Ref: 24025

Stables at Allington Lane, Allington, Hants F/24/96845
Condition #7 & #8 Surface Water Drainage Design

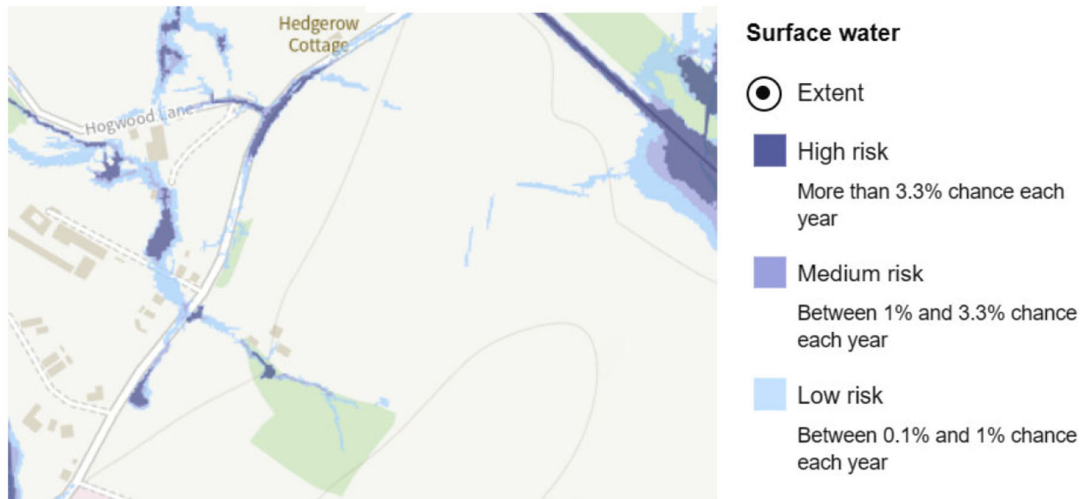
- make sure your field heap is at least 10 metres from any surface water (such as a river, pond or ditch) or land drain, or 30 metres if the land slopes at 12 degrees or more
- make sure the location of the field heap is not liable to being waterlogged or flooded
- locate field heaps at least 50 metres from a spring well or borehole
- move the field heap at least every 12 months
- leave a 2 year gap before returning to the same site
- keep a record of the sites used for field heaps and the dates of use

- You must show all the low risk areas suitable for temporary field heaps on your risk map if you plan to use them.
- Temporary field heaps must:
- be made from manure solid enough to be stacked in a freestanding heap
- not give rise to free drainage from within the stacked material
- occupy as small a surface area as is needed to support the weight of the heap without it collapsing

The manure control is being dealt with by others

To comply with bullet 1 highlighted grey the manure heap should be located sufficiently far from the ditch.

To comply with bullet 2 highlighted in grey the manure heap should not be located in areas at risk of surface water flooding:
